**Re HCC C/O district.plan@huttcity.govt.nz
Submission on publicly notified proposed
district plan.**

**OBJECTION /SUBMISSION OF JOHN
WADHAM
25/3/25**

SUBJECT Modelled Flooding at 23 Pomare Rd, Tirohanga - Update

Figure 1: Current modelled flooding at 23 Pomare Rd during the 1% AEP event plus climate change

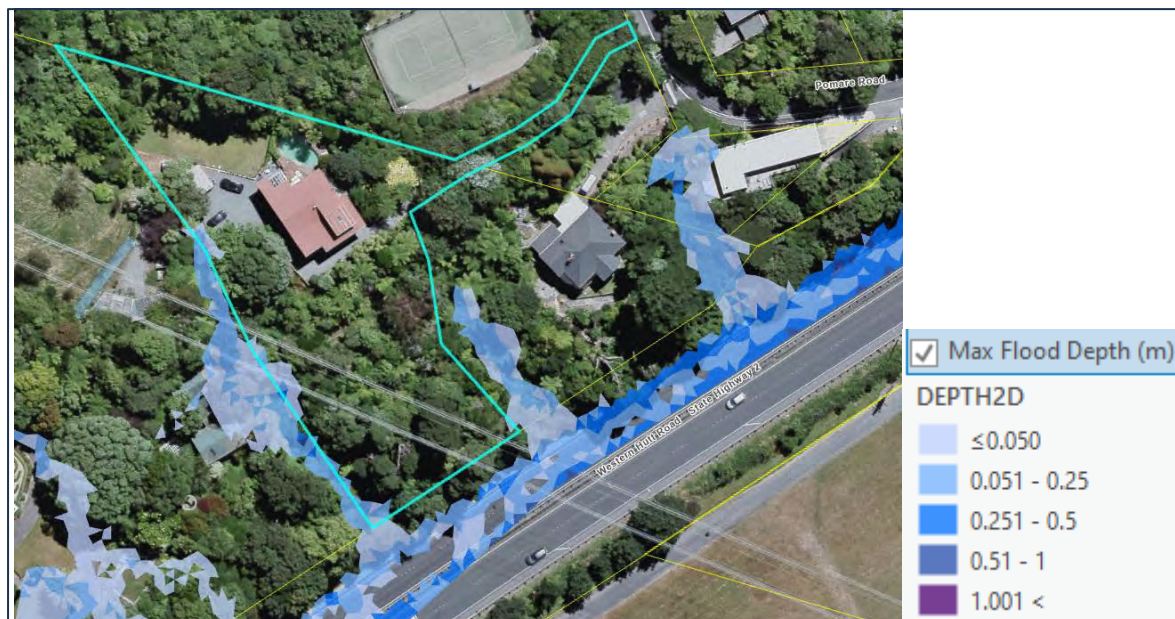
Following an initial investigation into the modelled flooding predicted at 23 Pomare Rd, Tirohanga, and discussions with the property owner, Wellington Water opted re-visit the site to assess the gully along the western boundary of the property and its potential impact on modelled flooding. The initial investigation, reported in the technical memo *Modelled Flooding at 23 Pomare Rd, Tirohanga*, resulted in updated flood and hazard mapping for the site (Figure 1). However, there was still some uncertainty regarding the nature of flooding through the gully which appeared to let flow 'spread out' rather than focusing it within a confined channel.

Figure 2: Model updates

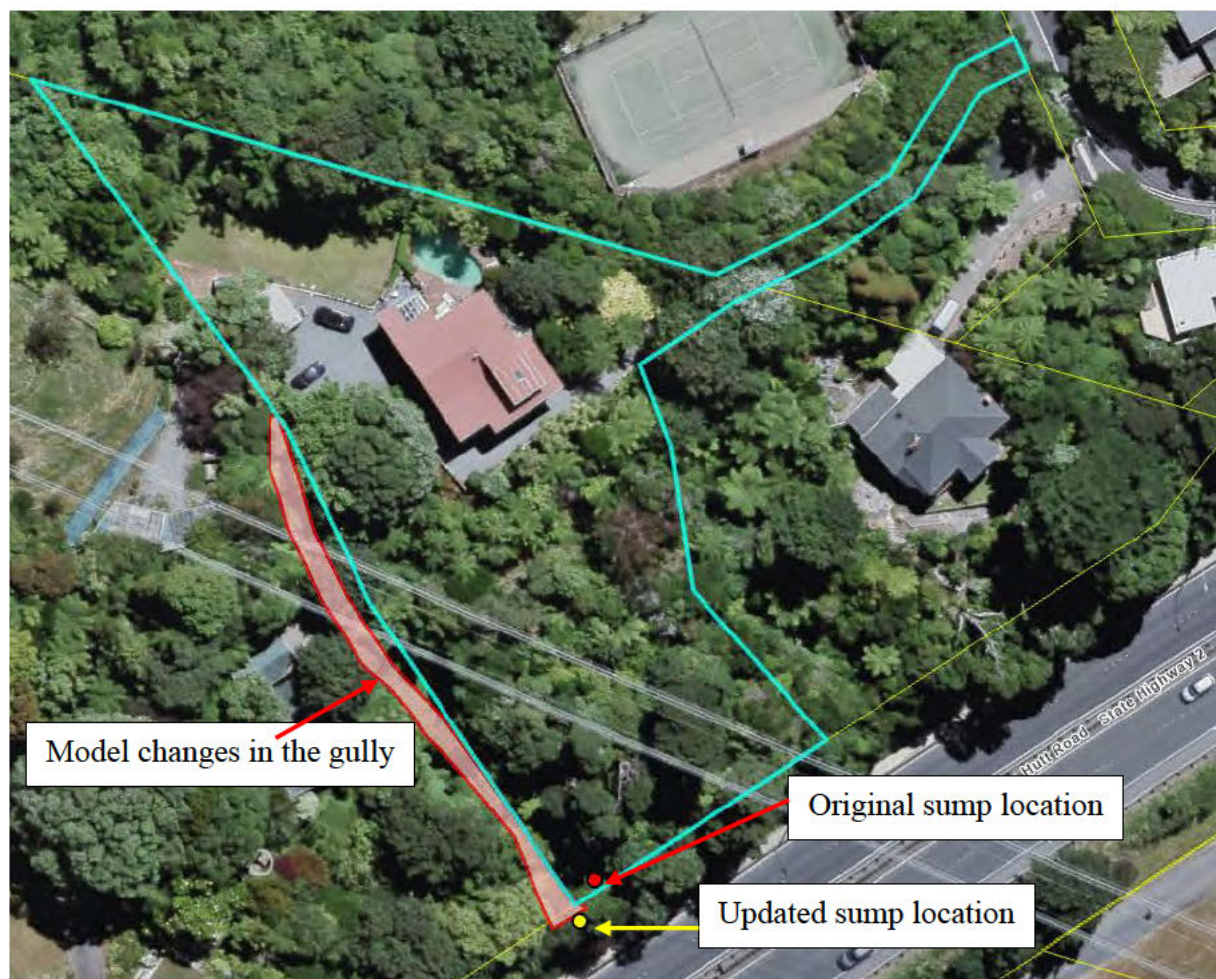
Wellington Water representatives visited the site on the 11th of June and confirmed where possible, via visual assessment, that the gully did have a formed channel that did not appear to be well represented in the modelled topography. To address this, changes were made to the model representation of the ground surface to accentuate the presence of a channel within the gully (Figure 2).

In addition to the gully, the Wellington Water representatives also inspected a stormwater sump located at the base of the gully (Figure 2). In Wellington Water asset data, the sump has been located in the southern corner of 23 Pomare Rd, however, the site inspection showed this sump is located on the footpath within the corridor parcel of State Highway 2. The sump location was also updated in the model to reflect this, see Figure 2.

Figure 3: Updated modelled flooding at 23 Pomare Rd during the 1% AEP event plus climate change

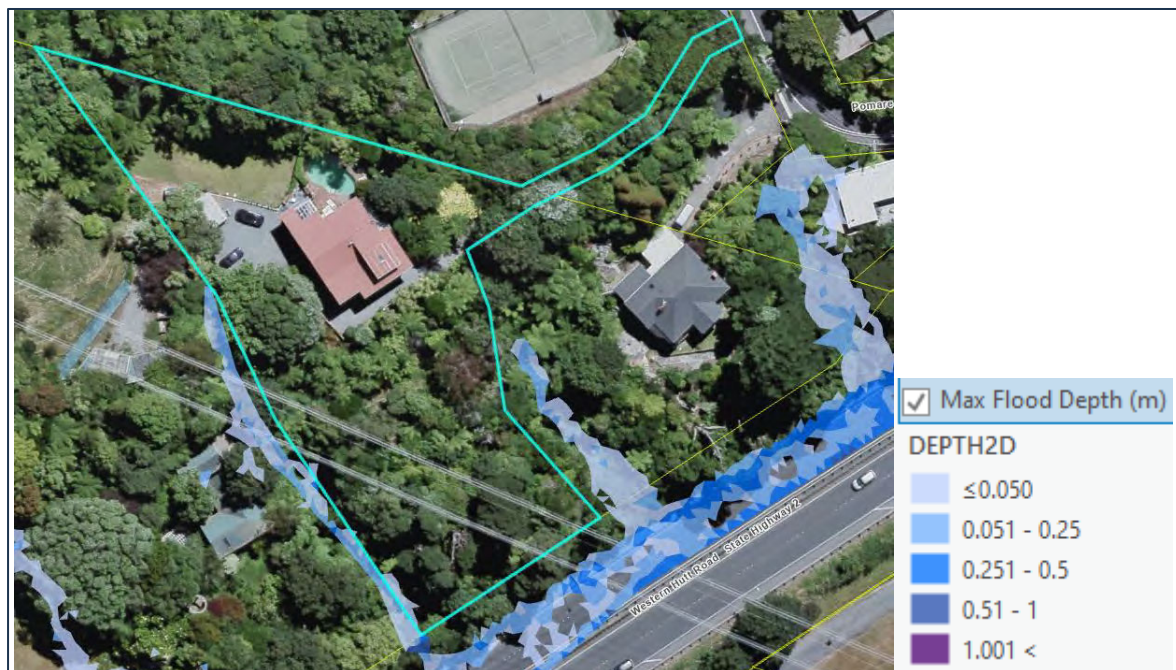
The result of these model updates is shown below in the flood depth map Figure 3. The new results indicate 23 Pomare Rd is only marginally impacted by nuisance flooding (less than 0.05m) along the western boundary of the property.

As part of the additional analysis undertaken by Wellington Water, the flood hazard maps that will be applied by Hutt City Council in the upcoming notified Proposed District Plan have been updated to reflect this updated modelling. Figure 4 below shows the extent of the updated flood hazard mapping in the vicinity of 23 Pomare Rd. The updated mapping shows there is no longer a modelled flood hazard on the property.

The updated model results show that the property is only impacted by nuisance flooding (less than 0.05m) along the western boundary of the property. This change will be reflected in the upcoming Hutt City Council notified Proposed District Plan superseding the current Draft District Plan maps, in which the proposed flood hazard maps will show no flood hazard on 23 Pomare Rd, Tirohanga. Wellington Water confirms they are satisfied with the outcome and consider there to be no modelled flood hazard on the property.
